Questions about Bidding for 7 Airports Project and Responses

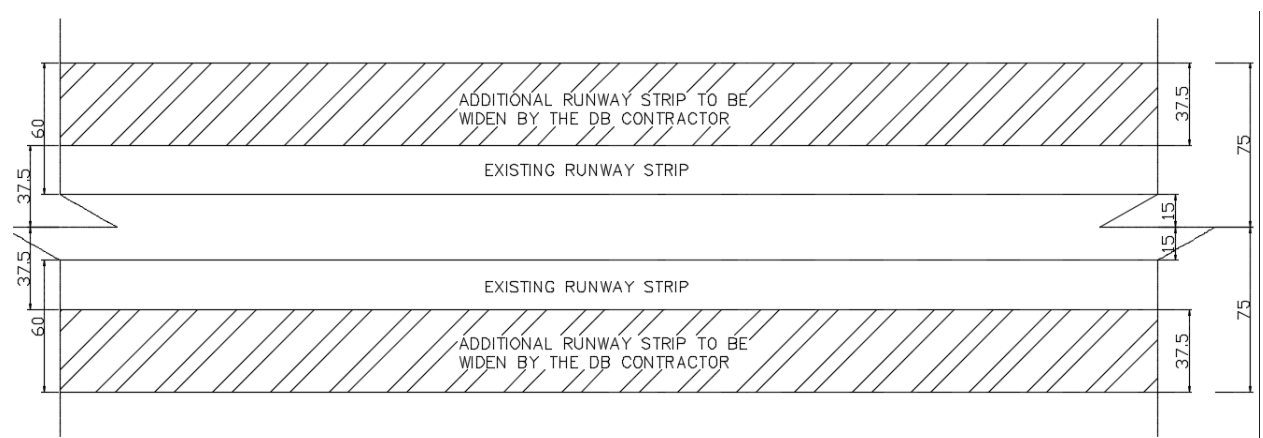
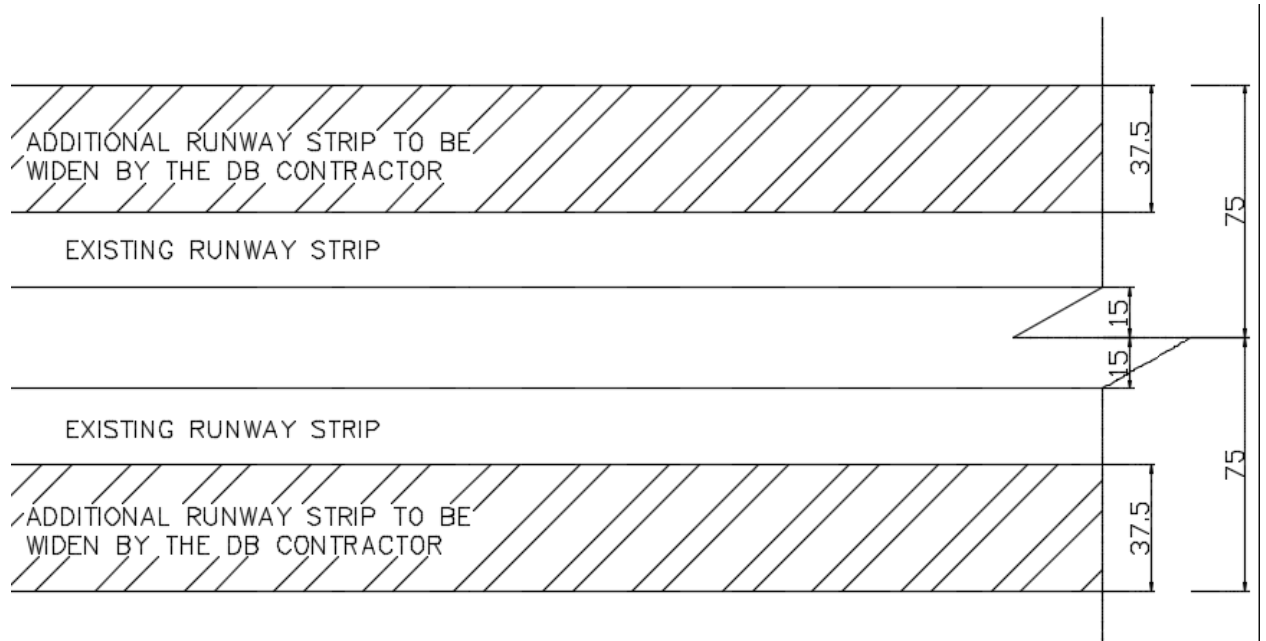
3. For the Dembidollo Airport, could you please clarify that widen of Runway strip means widen of earthwork or widen of Runway pavement surface?

As shown on the picture below, widen of runway strip means widening of earthwork (sub-base work and grassing work on the strip). Additional runway strip width to be extended by the DBC is 37.5 m
